# Access Compliance Report

### (Curb Ramps)

Intersection ID: 12761	Main Street: S_MINT_ST	Cross Street: W_CARSON_BV	Location: S
ADA ID: DFDCC94360A8	Ramp Type: PerpDiag	Initial Pass/Fail: Fail	Overall Compliance: No
Severity Score: 25			
Codes/Mitigation Info/Possible Solution		Field Measurements/Component Compliance

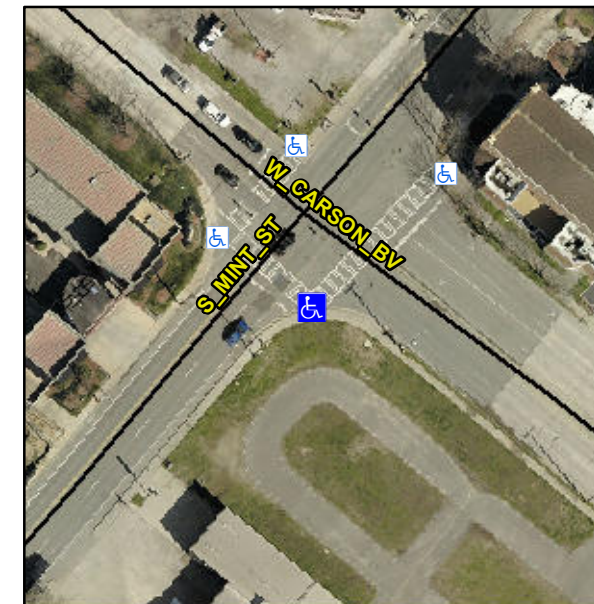
**R304.2.2, R304.5.3**

Compliance	Description	Data	Compliance	Description	Data
N/A	Ramp Length (in)	58.0	No	Ramp Slope (%)	8.9
Yes	Ramp Width (in)	48.0	No	Ramp XSlope (%)	5.6
N/A	Flare Type LT	N/A	N/A	Flare Type RT	N/A
N/A	Flare Slope LT (%)	N/A	N/A	Flare Slope RT (%)	N/A
N/A	Flare Traversable LT?	N/A	N/A	Flare Traversable RT?	N/A
N/A	Landing Length (in)	N/A	N/A	DWS Provided?	N/A
N/A	Landing Width (in)	N/A	N/A	DWS Contrast?	N/A
N/A	Landing Slope (%)	N/A	N/A	DWS Length (in)	N/A
N/A	Landing X Slope (%)	N/A	N/A	DWS Full Width?	N/A
N/A	Landing Curb? (Y/N)	N/A	N/A	DWS Offset (in)	N/A
N/A	Shared Landing?	N/A			
N/A	Gutter Ponding?	N/A	N/A	Gutter Slope (%)	N/A
N/A	Gutter Lip Ht (in)	N/A	N/A	Gutter X Slope (%)	N/A
N/A	Painted X Walk1?	Yes	N/A	Painted X Walk2?	Yes
	X Walk 1 Direction	To NE		X Walk 2 Direction	To NW
N/A	X Walk 1 Width (in)	108.0	N/A	X Walk 2 Width (in)	104.0
	X Walk 1 Slope (%)	1.4		X Walk 2 Slope (%)	3.5
	X Walk 1 X Slope (%)	3.0		X Walk 2 X Slope (%)	2.3

N/A	Ramp inside XWalk1?	Yes	N/A	Ramp inside XWalk2?	Yes
	Road Slope (%)	1.1	N/A	Clear Space?	N/A
	Road X Slope (%)	5.2	N/A	Clear Space to XWalk (in)	N/A
N/A	Any Obstructions?	N/A	N/A	Storm Grate/Utility Hazard?	N/A
	Obstruction Type			Storm Grate/Utility Type	
		N/A			N/A
		Yes		Surface Condition? (G/P)	Good

**Remove & Replace Curb Ramp With Two New Directional Ramps or Equivalent.**
